JERSEY CENTRAL POWER & LIGHT COMPANY  
OYSTER CREEK NUCLEAR GENERATING STATION  
(DOCKET NO. 50-219)  
PROVISIONAL OPERATING LICENSE NO. DPR-16

Applicant hereby requests the Commission to change Appendix A to the above captioned license as follows:

This Technical Specification change delineates the new management organization that has been developed by combining the management and technical staff from within the GPU Service Corporation, Metropolitan Edison Company and Jersey Central Power & Light to form the GPU Nuclear Group.

FIGURE 6.2.1

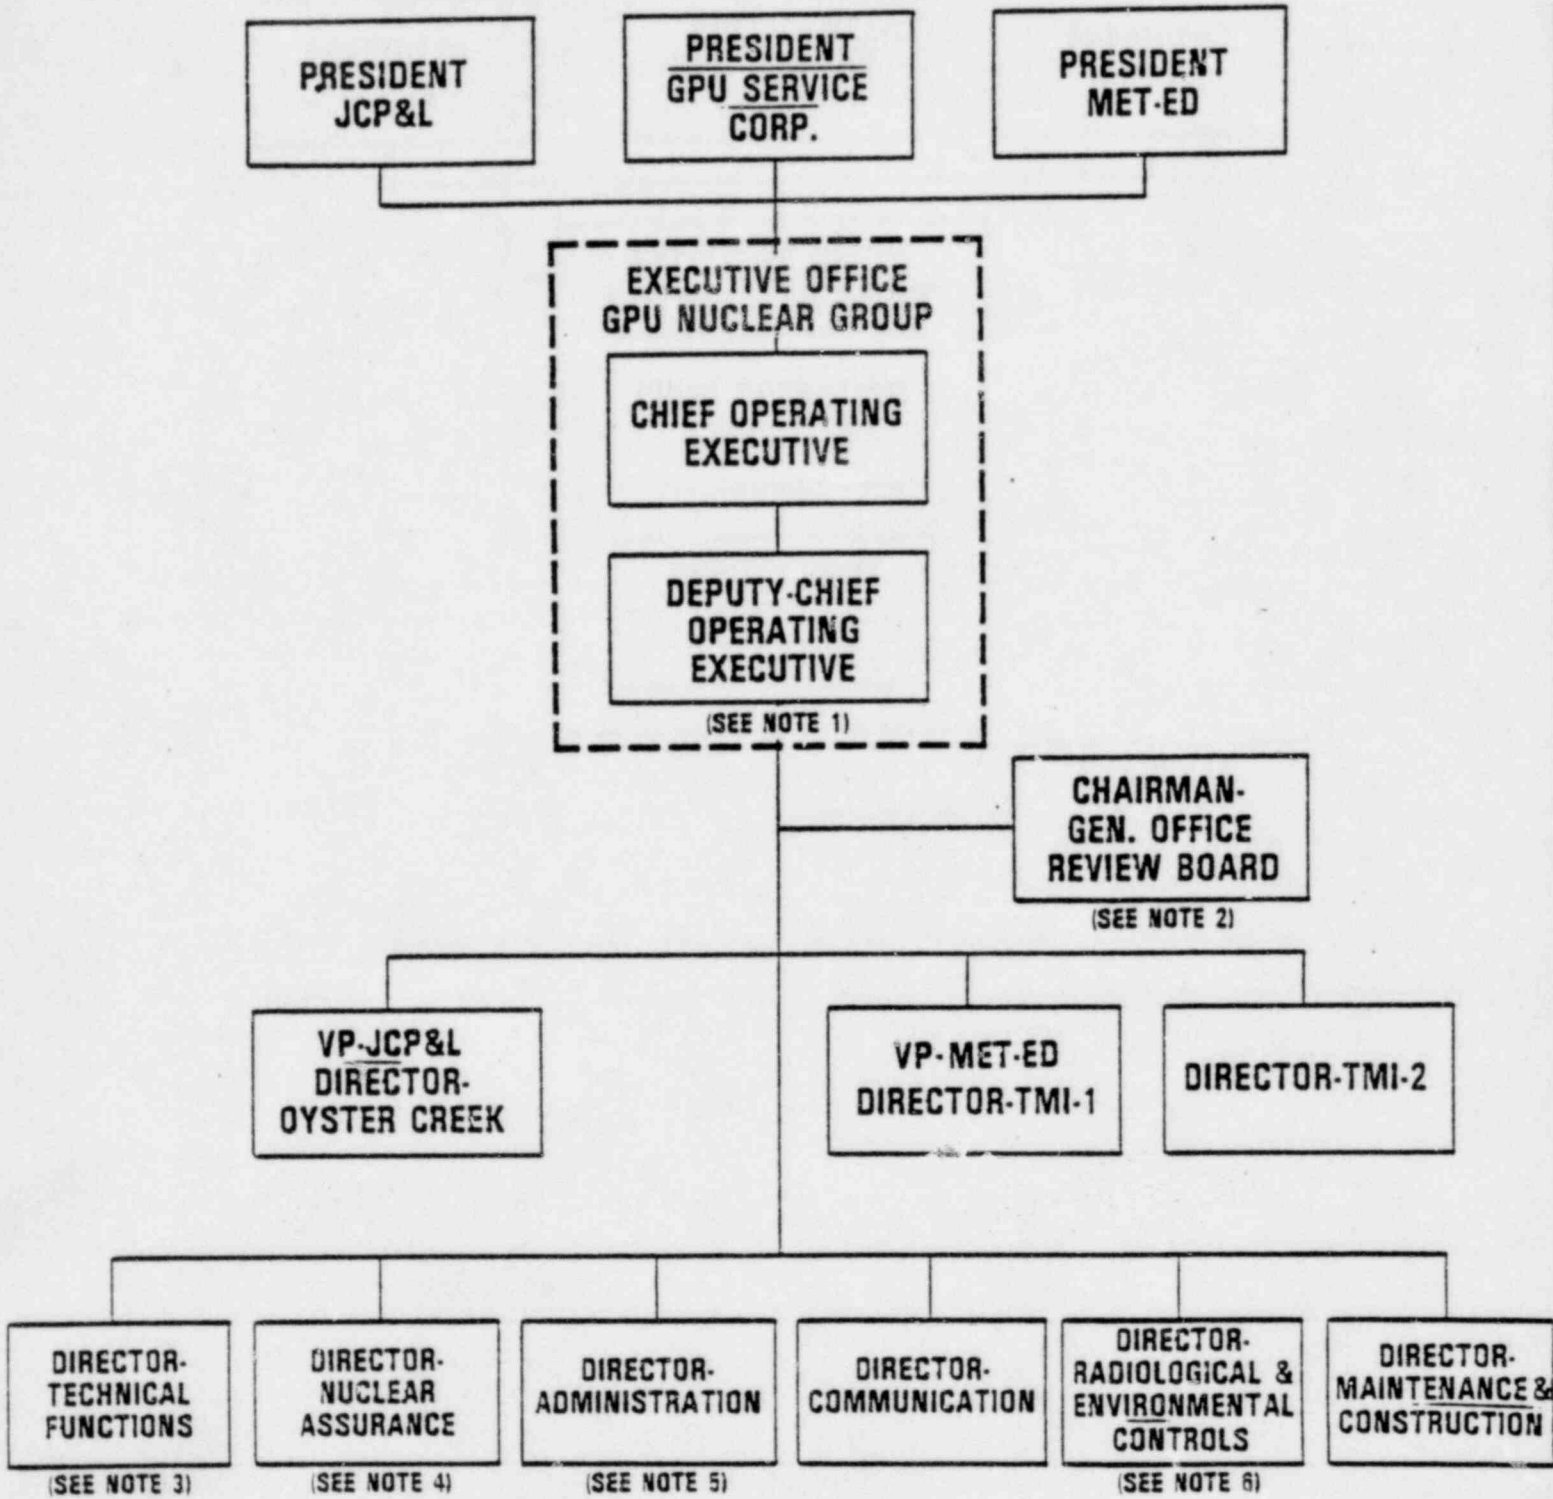
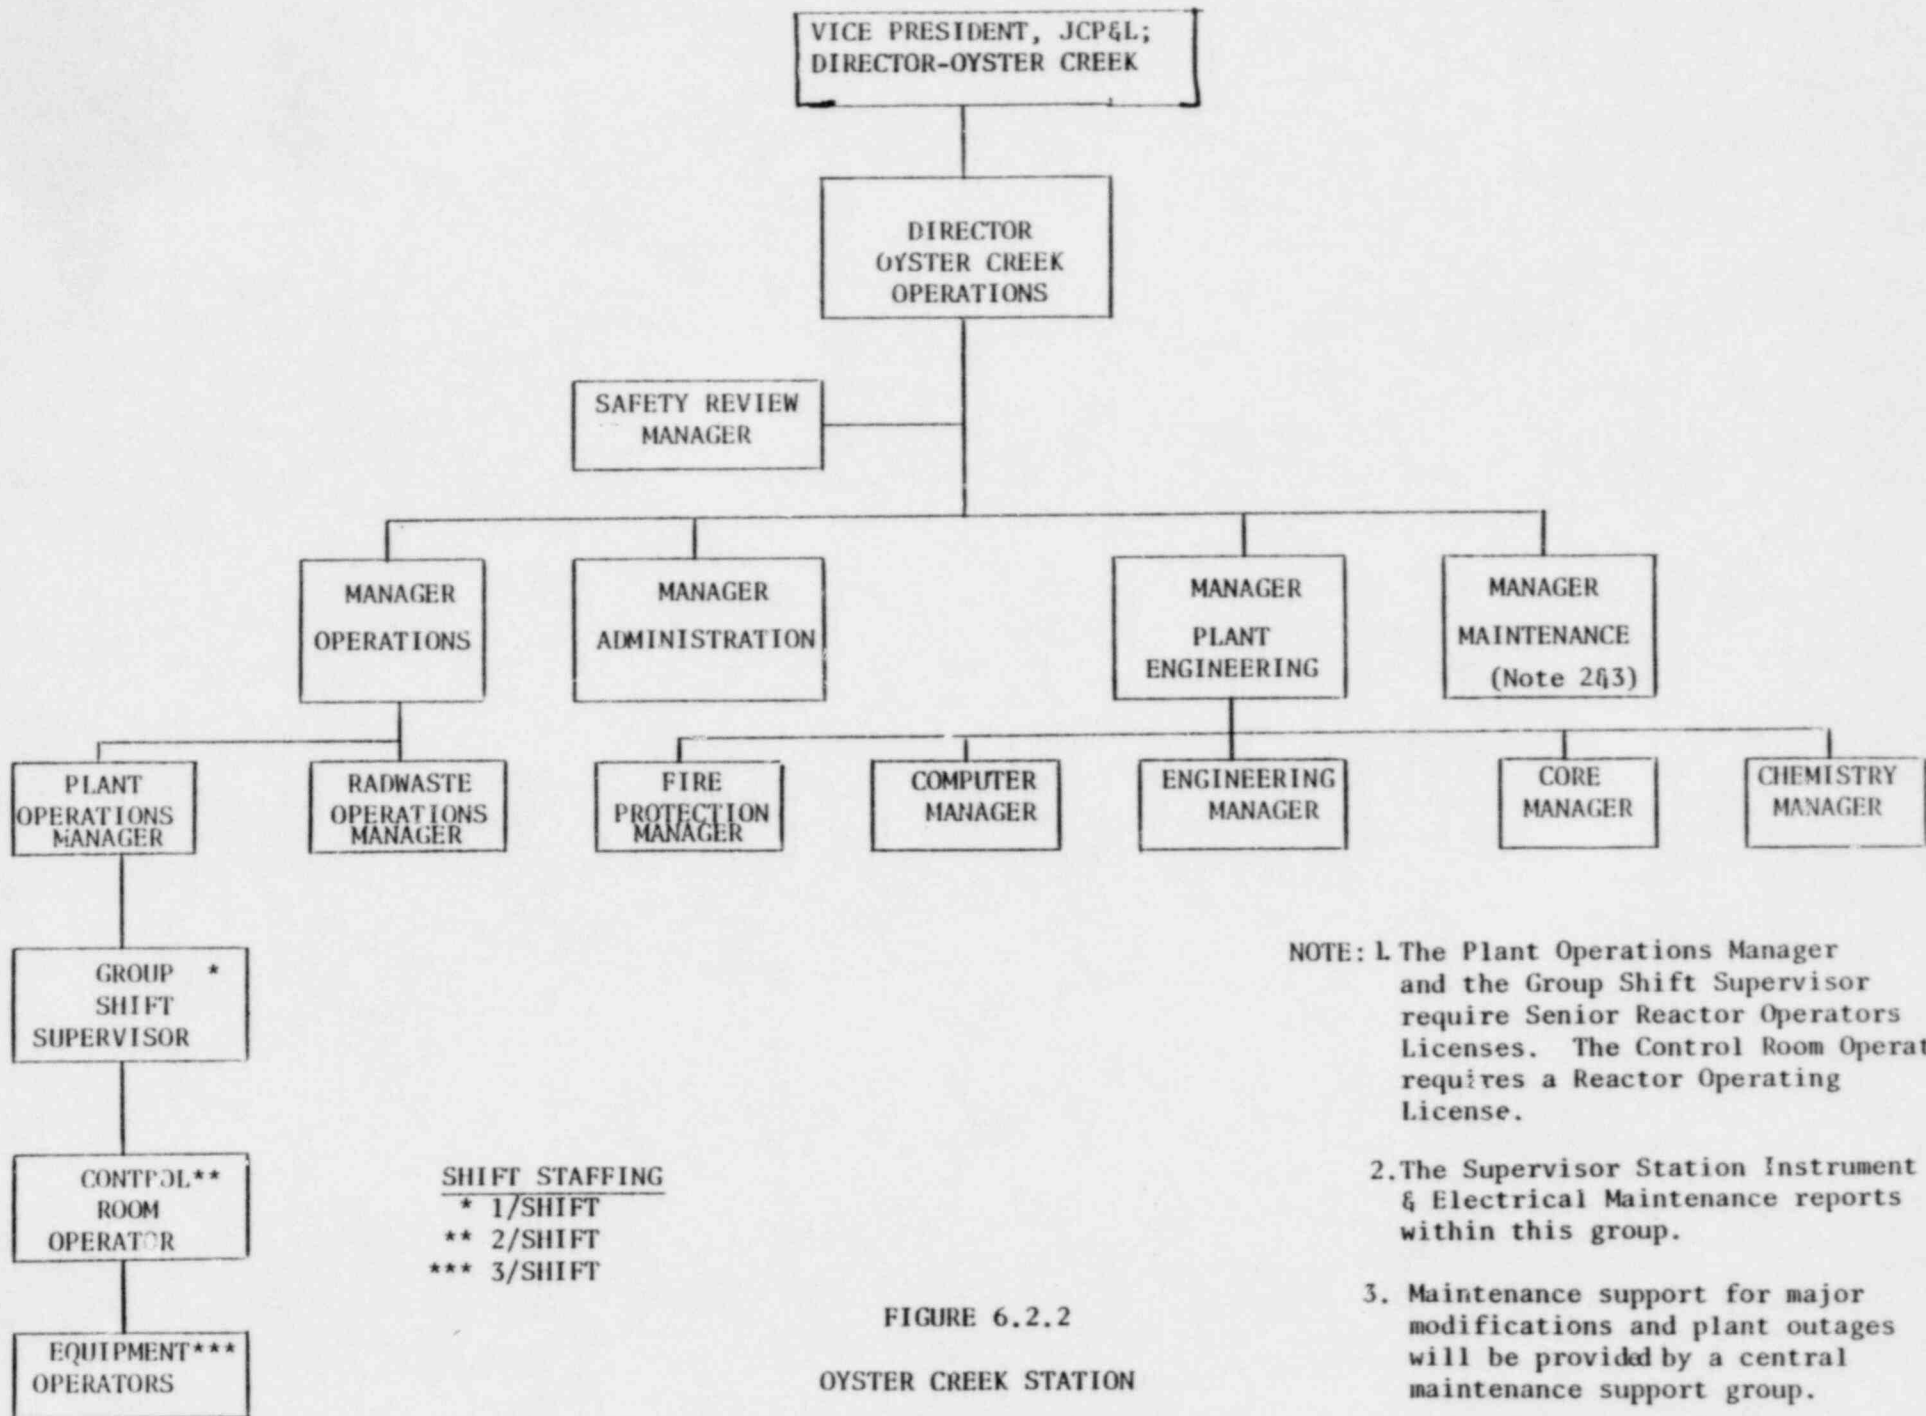
Several positions which were previously indicated on an organization chart may no longer appear because of the reassignment of that job function to another organization or due to the level of detail shown on the figures. Positions that fall in this category are listed below along with where this position or function is covered:

4. Site Quality Assurance is still located at the Station. This function reports to the Nuclear Assurance Division within the GPU Nuclear Group.
5. The Management Control Supervisor has been deleted from Figure 6.2.2 although the position still exists, because he has been replaced on the PORC by the Safety Review Manager.

6. The functions of Supervisor Station I & E Maintenance and Supervisor Station Mechanical Maintenance are still located at the station and report to the Manager Maintenance.

7. The functions of Generation Engineering, and Nuclear Safety & Licensing report to the Technical Functions Division. Although these are GPU Nuclear Support Groups there will be satellite groups at the station.

8. The Manager Environmental Affairs is presently responsible for Nuclear and Environmental Licensing, and Environmental Monitoring. Under the proposed organization, Nuclear and Environmental Licensing will report to the Technical Functions Division while the Environmental Monitoring group will report to the Radiological and Environmental Control Division.

9. The JCP&L Corporate Operational Quality Assurance Group will be incorporated into the Nuclear Assurance Division within the GPU Nuclear Group.
10. The present responsibilities of the Plant Support Superintendent will be assumed by the Manager Plant Engineering under the new proposed organization.
